AMENDMENTS TO THE DRAWINGS:

FIG. 1

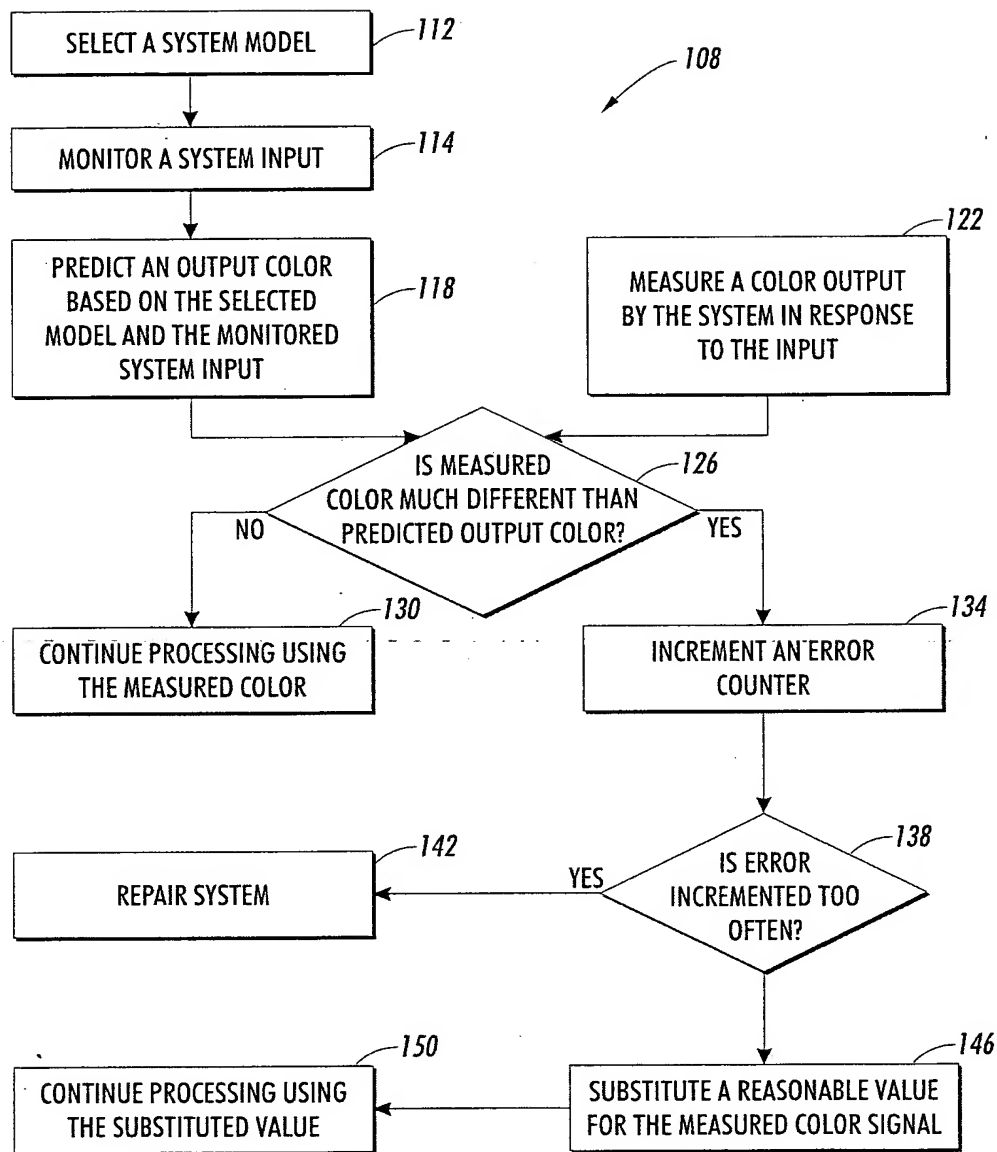
The attached drawing sheet includes changes to FIG. 1 by correcting the text in box **150**.

As originally filed, the text in box **150** read -- continue processing using a measured color --. In the replacement sheet being submitted herewith, the text in box **150** is being changed to read -- continue processing using the substituted value --. It is respectfully submitted that this correction is supported by the logic of FIG. 1, including, for example the text of box **146** which leads to box **150**. The text in box **146** reads -- substitute a reasonable value for the measured color signal --. Therefore, it is respectfully submitted, it is only logical that the box following **146** (i.e., **150**) should read continue processing using the substituted value. Additionally, the correction to box **150** is supported throughout the specification, and page 4, line 26 - page 6, line 21 in particular. For example, page 6, line 6-7 explain that a signal substitution **146** temporarily replaces the color measurement signal with a preferred reasonable value. Page 6, lines 9-10 explain that whatever value is selected to be the preferred color signal, that value is used for further processing **150**.

For at least the foregoing reasons, it is respectfully submitted that the correction to FIG. 1 does not represent new matter and should be entered.
